# INTERNATIONAL BUILDING CODE – MEANS OF EGRESS

## E2-06/07

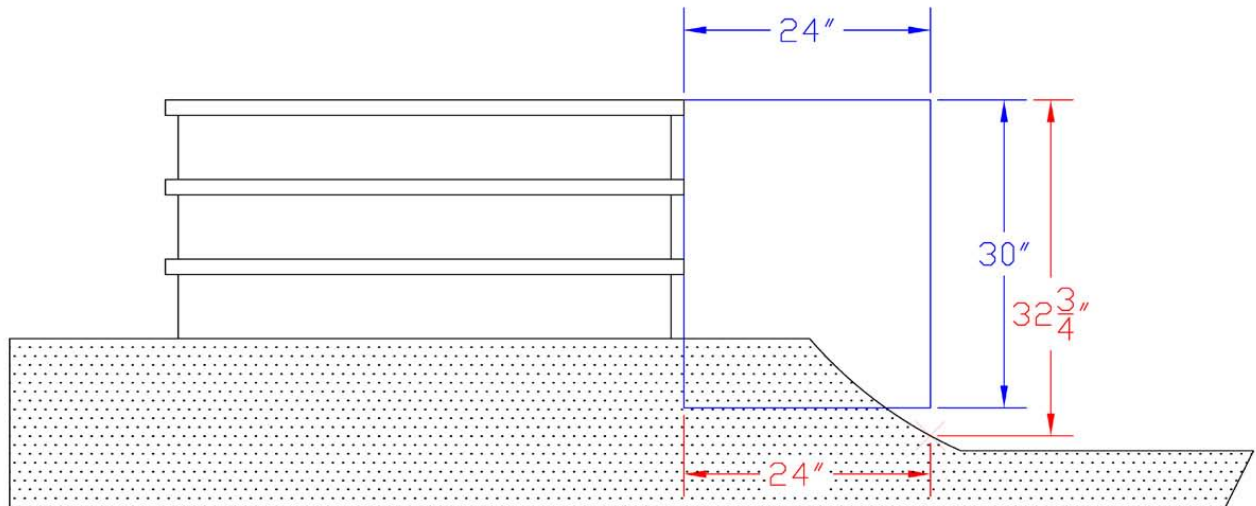
The diagram below was drawn by the author and is shown as a visual guide or technical drawing. The drawing shows a 3 riser front entry stoop with 7-3/4" risers from a front elevation. The ground is detailed in outlined dots. The 24" horizontal with 30" vertical box shows the area in which the code change submits the measurements should be taken. The 32-3/4" vertical point shows the deepest point within the 24" horizontal edge measurement.

Thus if this stoop was on a home it would require a guard be installed on the right side only as the left side is not 30 inches or more deep.

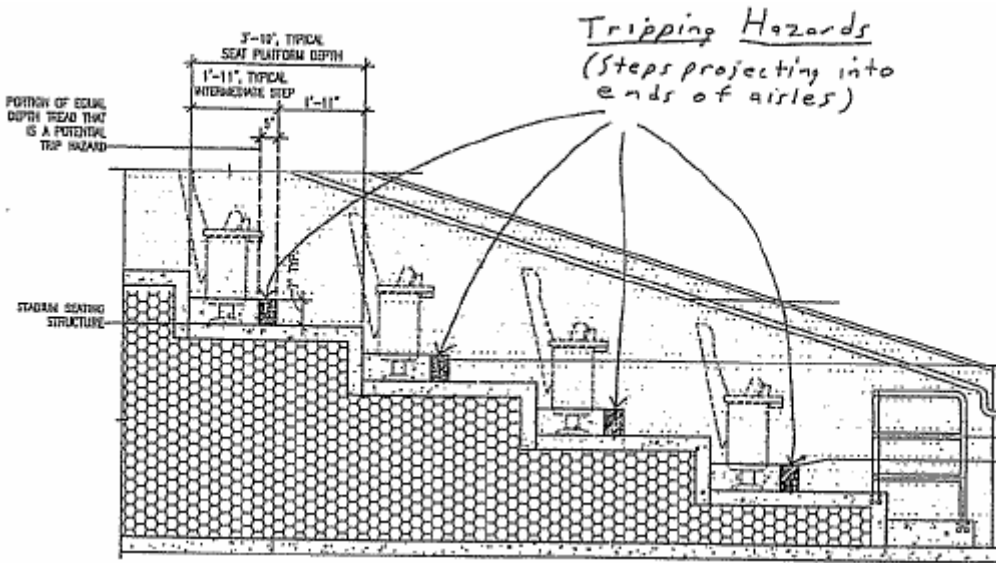
The concern addressed with the non-uniform treads is that it will potentially create a trip hazard. This is presumably due to the cadence that would be developed walking a set of steps. In a traditional set of stairs, this is largely true. However, while there are times when a person will walk the stairs upward prior to the event similar to a stair, after the event the conditions change. Unlike a typical stair where a person walks at a regular pace, after an event, occupants walk very slowly on a set of stairs. As people are trying to enter the aisles from the seating rows, travel is reduced to a slow pace. A person will in some cases shuffle feet and not take actual steps due to this slow down.

Another issue with cadence is that it is developed after a few steps.

If all the non-uniform steps are consistent, as is required in the modification, a cadence will be developed but not a traditional one. In walking steps with depths between approximately 13 inches and 18 inches a single step is taken. Between 18 inches and 24 inches two steps are taken. What happens in uniform tread aisles is that a person takes two small steps and then two large steps or will change cadence because it does not feel comfortable. In non-uniform treads, there is a single step on the short treads followed by two on the longer tread. Thus a cadence is developed which allows faster movement. The greater the number of steps, the greater the potential for tripping.
